Development Facilitation Team (DFT) – Review Comments

Project No: PR-2019-003221 Date: 04/10/2024 Agenda Item: #5 Zone Atlas Page: D-17

**Request: INTERIOR LOT LINE ELIMINATION BETWEEN TWO EXISTING LOTS TO
CREATE ONE NEW LOT, GRANT PUE ALONG WASHINGTON ST NE, DEDICATE
ADDITIONAL RIGHT-OF-WAY TO HAWKINS ST NE RIGHT-OF-WAY**

Application For: SD-2019-003221 – PRELIMINARY/FINAL PLAT

FIGURE 7.2.41 Street Element Dimensions Along Major Roads

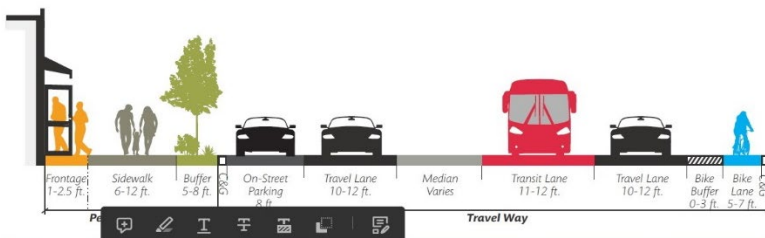
- Demonstrate compliance with section 7 of the DPM Table 7.2.29 and Required Improvements section from 5-4(N) of the IDO in regards to the sidewalk width requirements and the accompanying landscape buffer.

Provide measurement for the existing ROW and distance from curb to property line along street frontage.

- Hawkins Street is considered a Major Collector Street and requires a 6-foot side walk and 5-6-foot landscape buffer. Please clarify regarding the landscape buffer size. Staff notes that the application submittal includes a response to Transportation comments from the January 8, 2020 Sketch Plat, noting that an Infrastructure List (IL) will be provided to include a 6-foot wide sidewalk along Hawkins. However, an IL was not included with the submittal.
